## **Materials... details of Listed Building Alterations as per application form...**

## **Heritage Statement for Cliffroyd, Covert Hill, Robin Hoods Bay .. YO22 4SN**

Our ref: NYM\2020\ENQ\16239

## **Pre-application advice for internal and external refurbishment works at Cliffroyd, Covet Hill, Robin Hood's Bay**

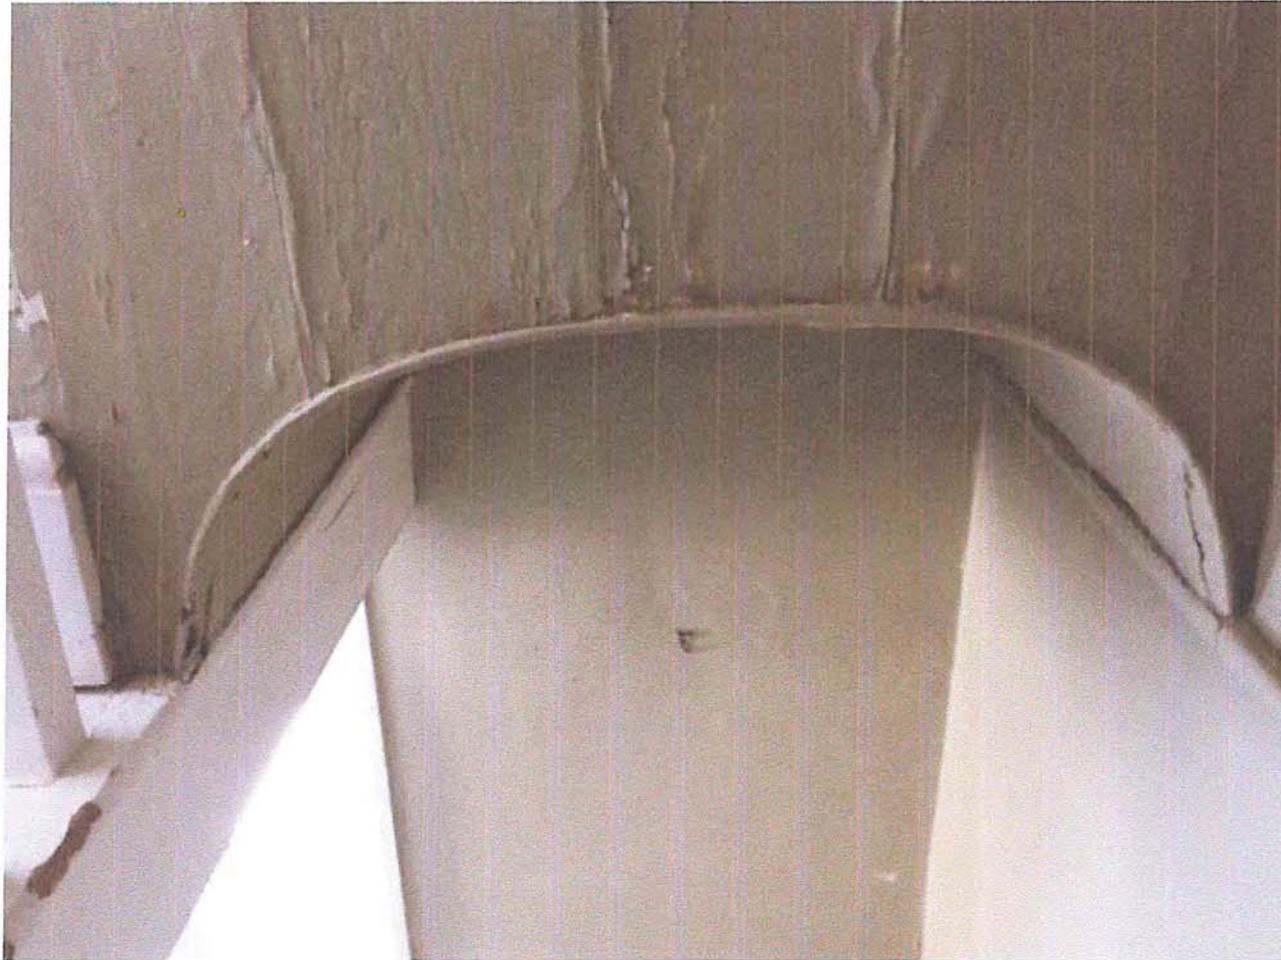
front door - replacement like for like

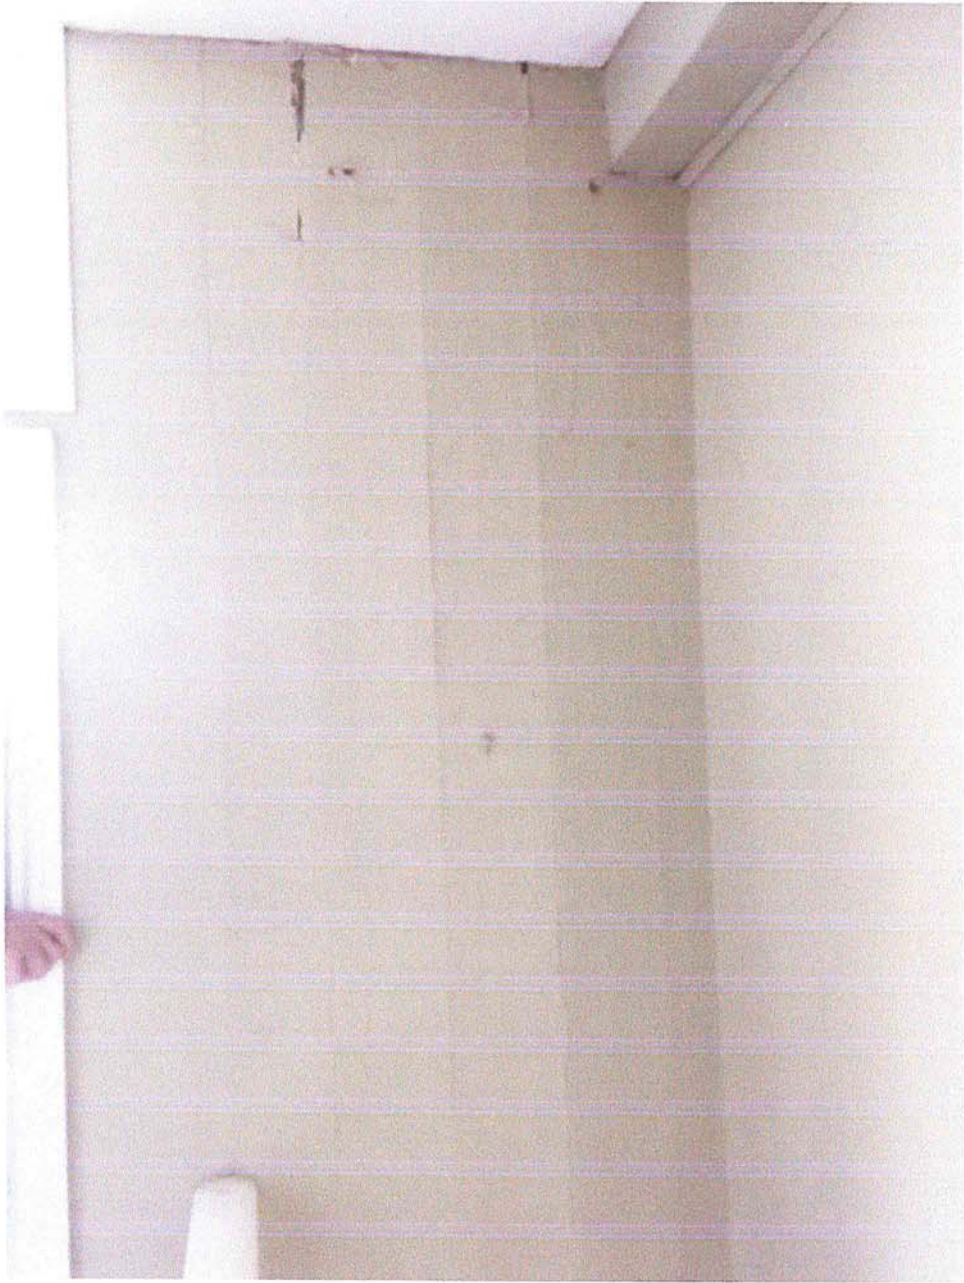
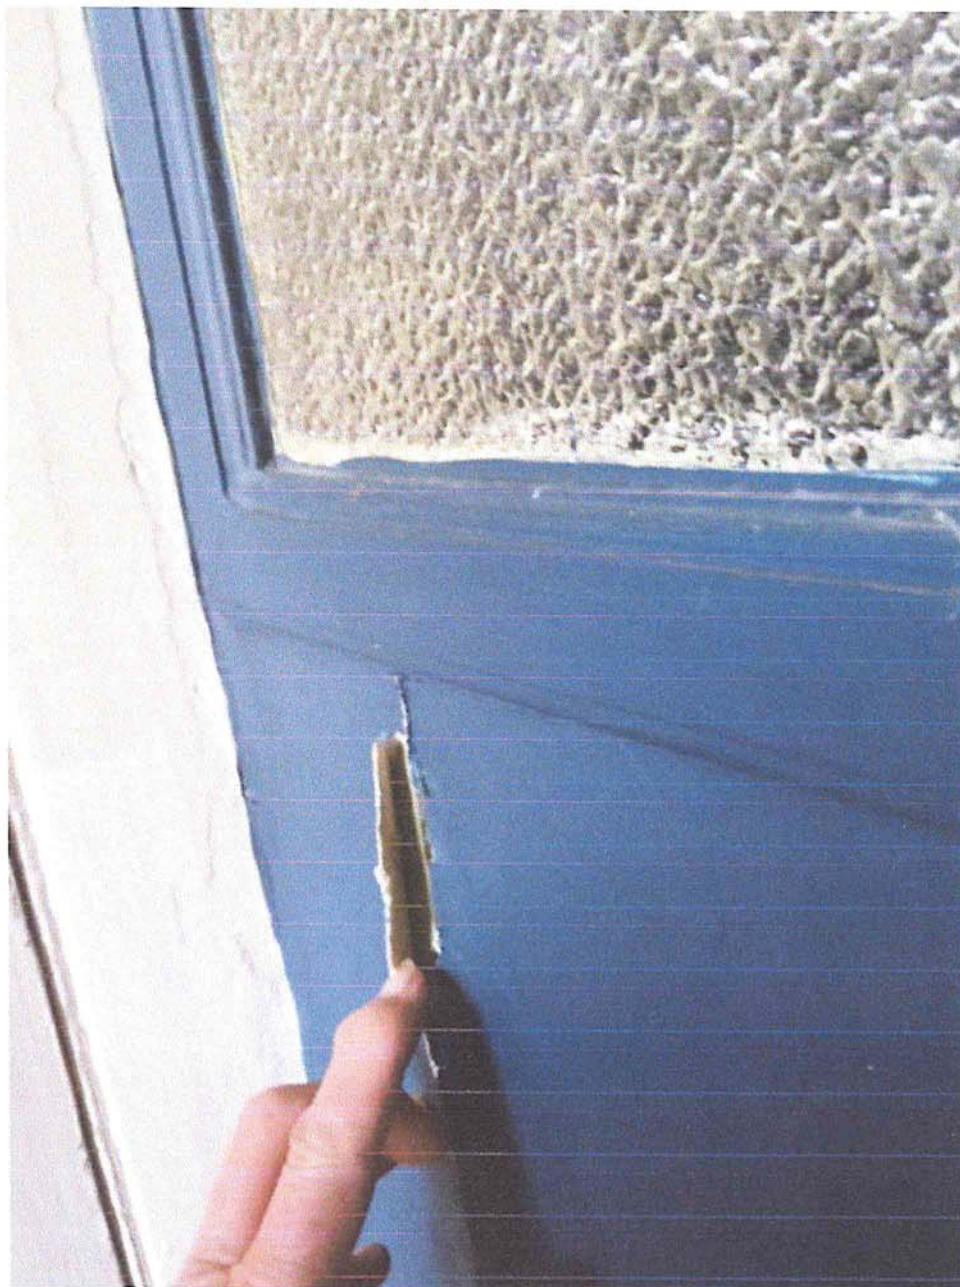
overstair paneling  
(replace like for like  
if required once  
cleared of paper)

under the  
overbains paneling  
arch

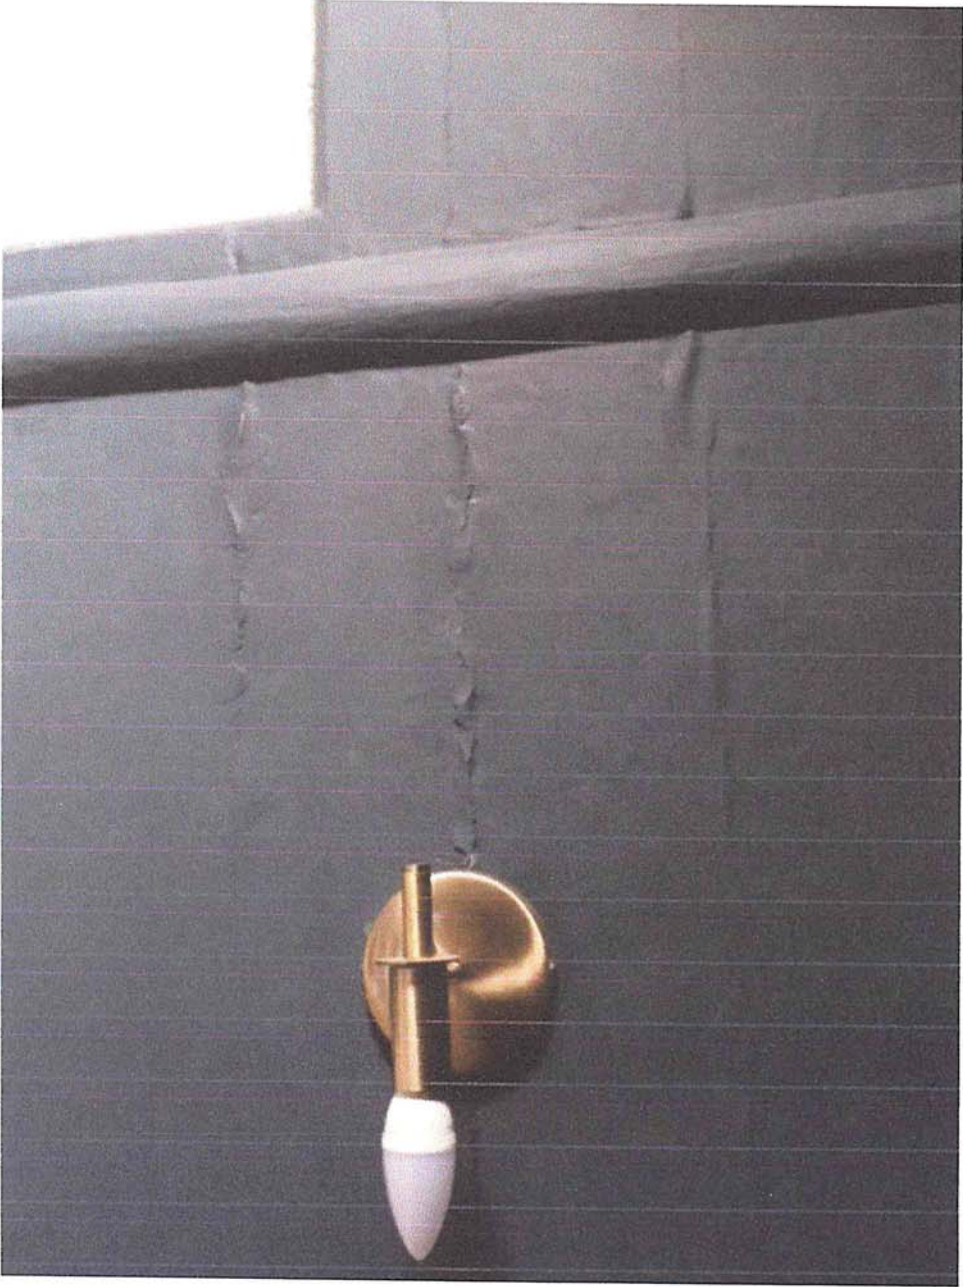
Similar  
paneling  
boy bedroom  
(replace like  
for like)

undersains cupboard.

concrete needing  
removal and  
replacement  
with limecrete

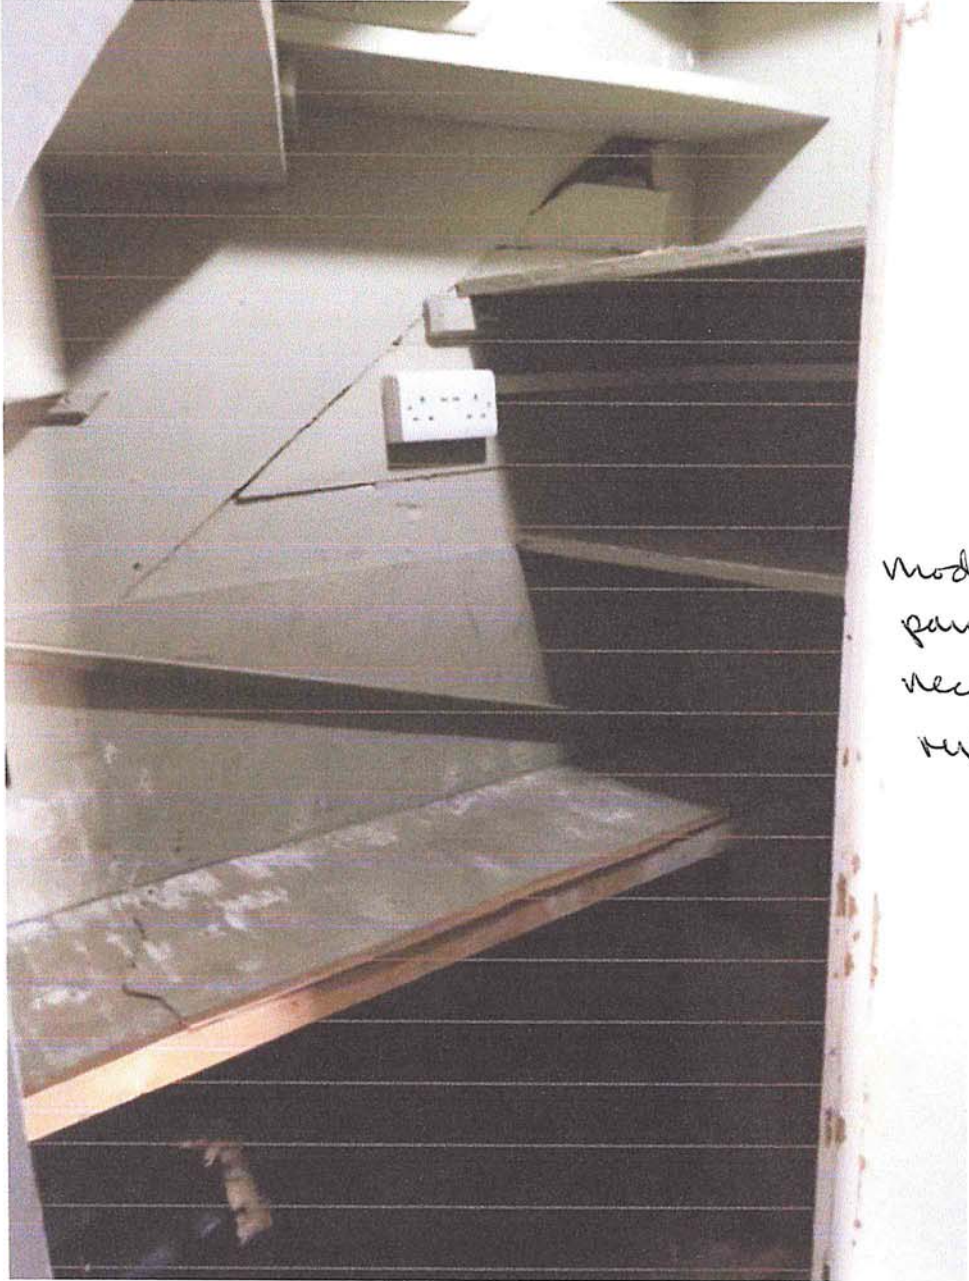
Modern  
paneling  
needing  
replacement

Modern shelf and  
panelling needing  
replacement

Modern  
panelling  
needing  
replacement

- A panelled door of 190 cm height to match the others in the property (see other photos)  
gap above to be plain panelled with fire proof board
- door opening inwards to the kitchen .

- wooden door frame fixed to kitchen side of wall so not relying on exposed stonework

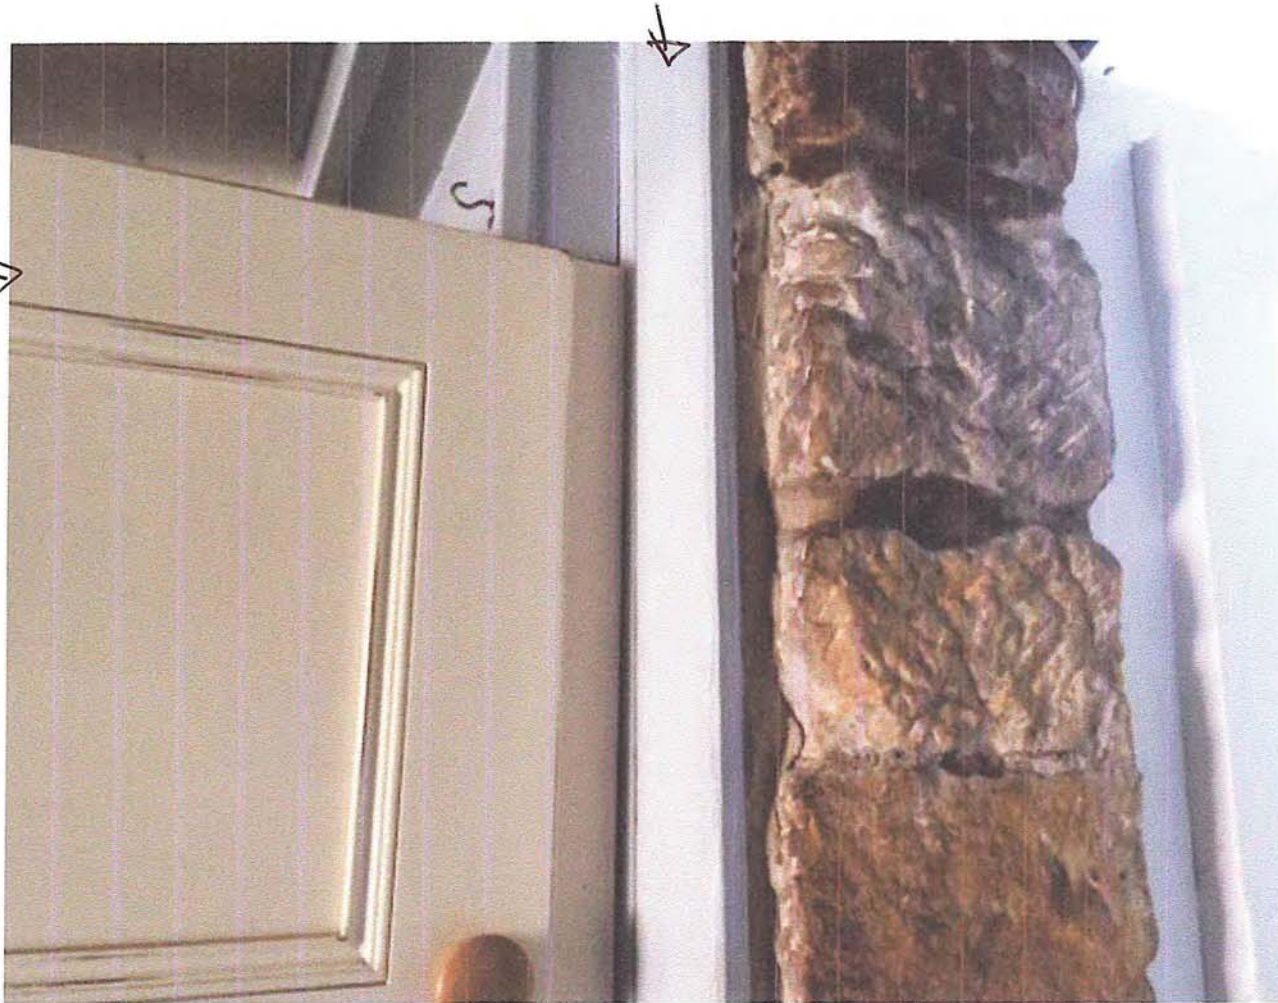
NB  
enclosure to  
be able to  
open in  
reverse to  
now.

door closes to this frame  
↓

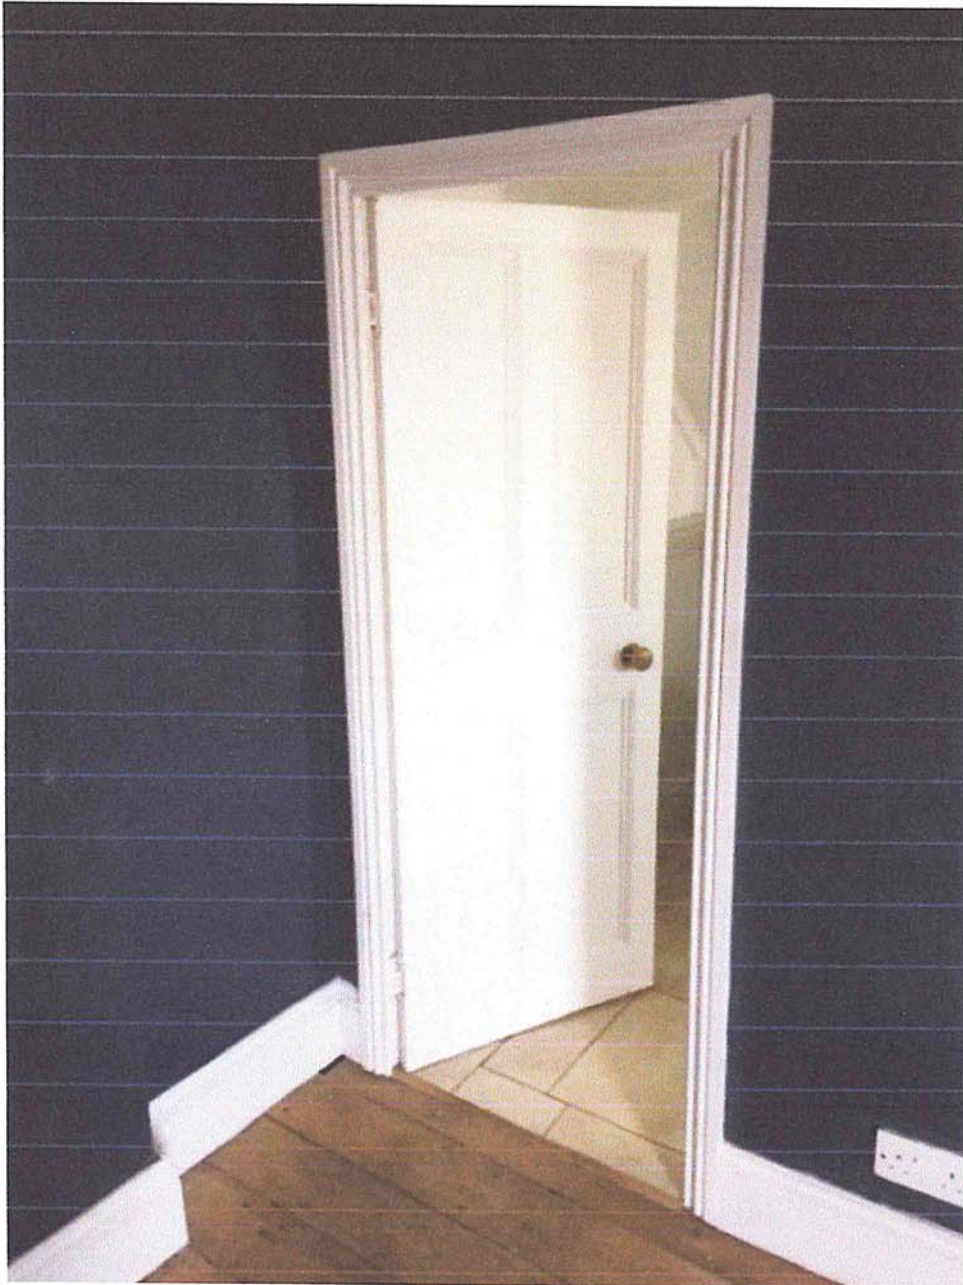
Replace like for like in design but as a fire door — at present this door has a large ( $>3\text{cm}$ ) gap at the bottom edge —

- present door height 163cms.
  - replace door with height of 185cm so  
adjust door lintel and raise this - 4panelled door
- [This door is a modern addition in a plaster board room divider]
